**SUBJECT:** NRC STAFF ASSESSMENT OF DUKE ENERGY CAROLINAS, LLC., OCONEE EXTERNAL FLOODING ISSUE (TAC NOS. ME4441, ME4442, AND ME4443)

ML102990064

**NRC Assessment of Oconee External Flooding Issue**

**Satellite image of Jocassee Dam showing submerged quarry site and embayment area below the dam which has a restricted outlet connection to the rest of Keowee Lake**

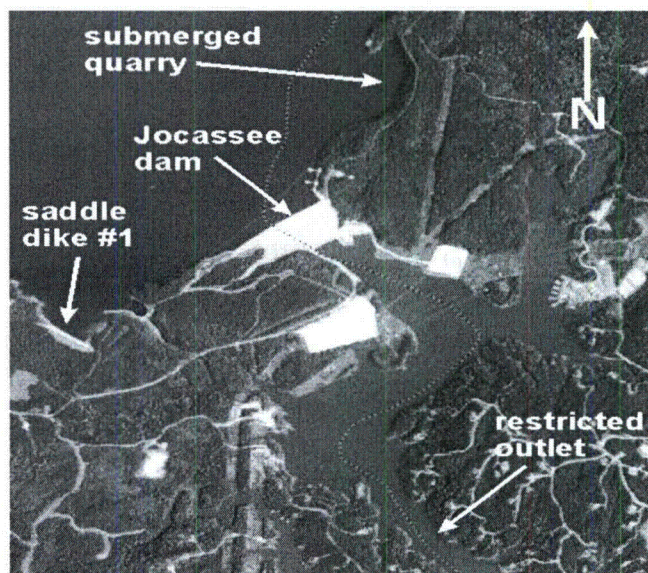
The tailwater effect of the convoluted flood pathway below Jocassee Dam was not considered. A limit on the depth of hypothetical breach cutting at Jocassee (and therefore on the peak discharge) is provided by the tailwater elevation of 800 ft, which represents the Keowee normal pool level. This is the base elevation that is assumed for the hypothetical breach at Jocassee. It is conservative to not include the tailwater effect of the convoluted flow pathway below Jocassee Dam because this would shorten the time required to empty the reservoir.

Flood path from the Taum Sauk dam breach.

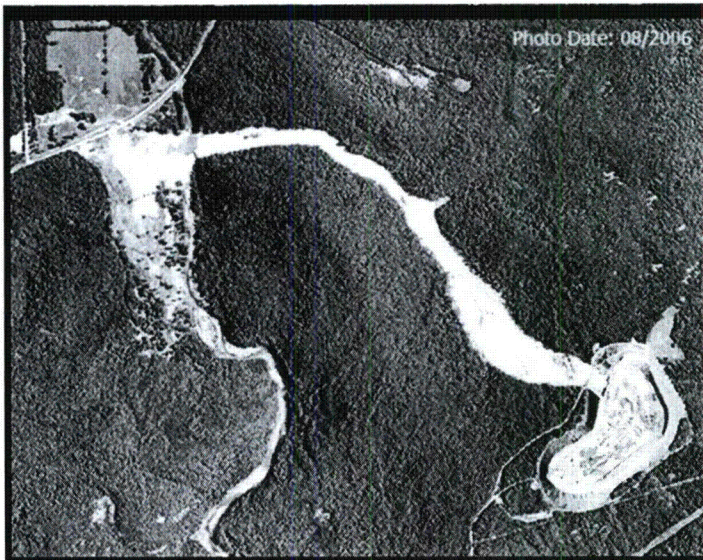
The scouring effects of the flood waters were not considered. The effect of this scour would be to enlarge the channel system (compared to its present width and depth) and accelerate the transport of floodwaters southward away from the site, so conservatisms were added at the water levels at the site. Mapping of flood scouring effects has been documented by various authors, including the recent work of Krizanich (2010) downstream from the Taum Sauk reservoir. See the scoured flood path in the figure below.

Figure 2: TWO-DIMENSIONAL MODEL BOUNDARY DEFINITIONS (Duke, 2010)

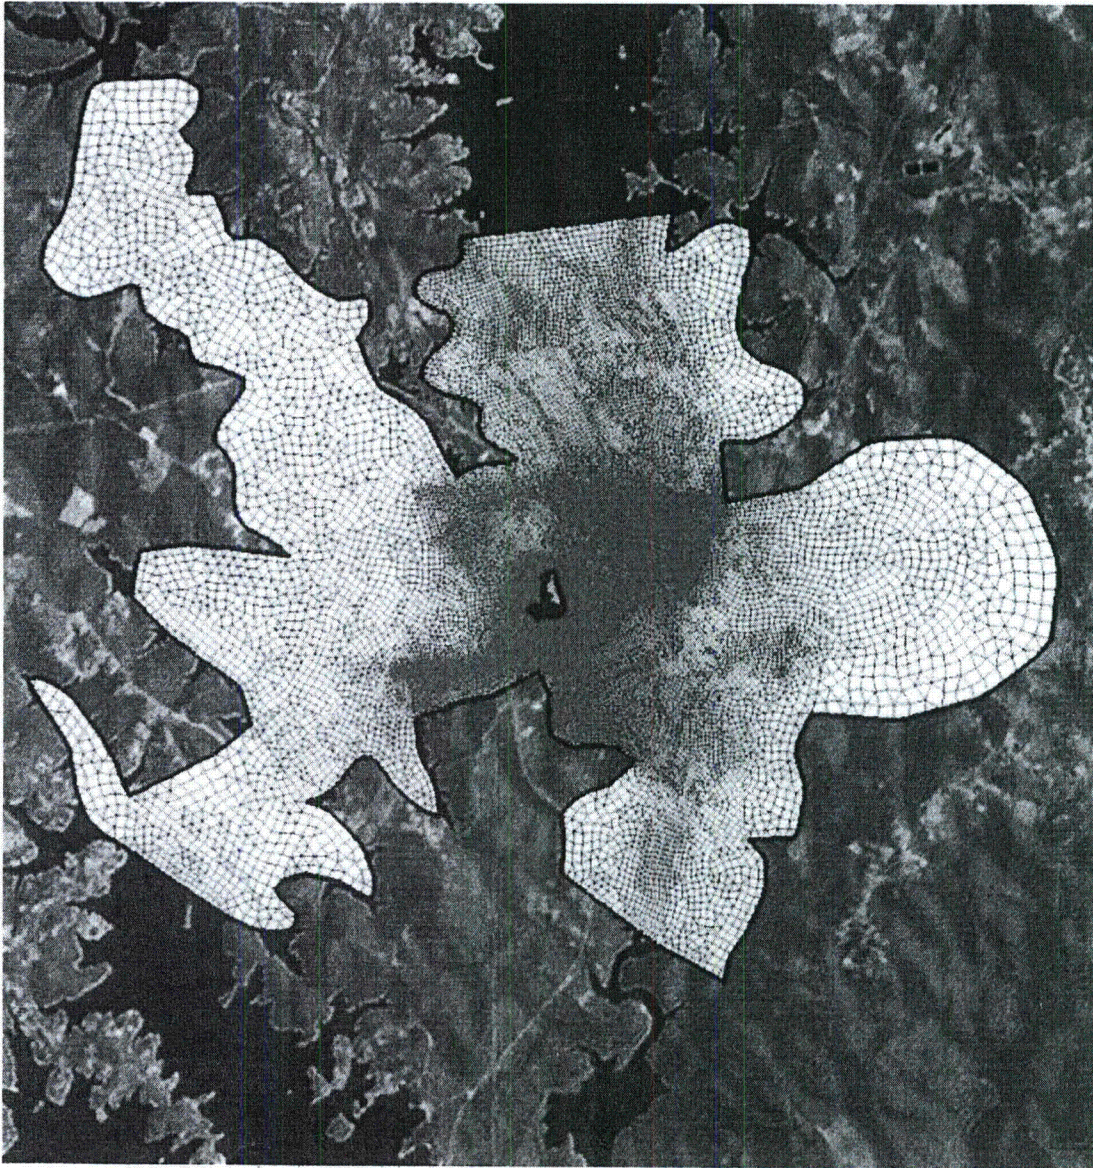
The 2-D model chosen was one developed by the U.S. Department of Interior Bureau of Reclamation entitled Sedimentation and River Hydraulics – Two Dimensional River Flow Modeling (SRH-2D). For the modeling effort, a 2-D Mesh of triangular and quadrilateral elements was constructed of the area surrounding the station. The mesh size was selected to model the desired area while keeping the computational array to a manageable size. The final computational mesh has approximately 57,500 unstructured elements. The mesh is coarser in areas that are farther away from ONS and finer in areas where more detail is required. As shown in the above figure, the upstream boundary is about 6,200 feet wide and the upstream boundary

condition consists of an inflow hydrograph. The downstream boundary conditions consist of stage hydrographs.
